TECHNICAL SERVICE BULLETIN

NO. 3 D 11

Automatic Transmission
Soft Engagement Modification

Austin America

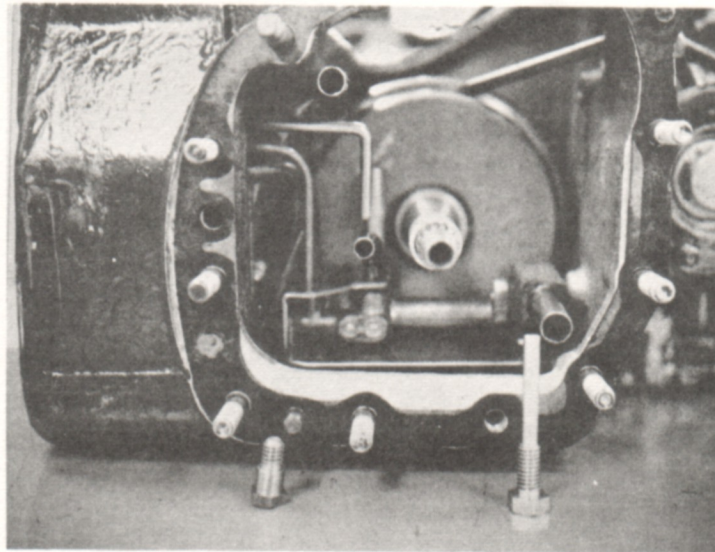
As from approximate serial number AA2 SDUA 8680M and all engines prefixed 12H 452E, a revised feature to soften the engagement of first and reverse gears has been introduced. The device incorporates a double shuttle valve mounted on the existing valve block and an engagement control valve mounted in the space ahead of the forward clutch and above the auxiliary pump oil strainer and secured by two dowel bolts as shown in Figure 1.

After removing the auxiliary pump and governor housing, the engagement control valve can be taken out and in fact must be removed before taking out the forward clutch.
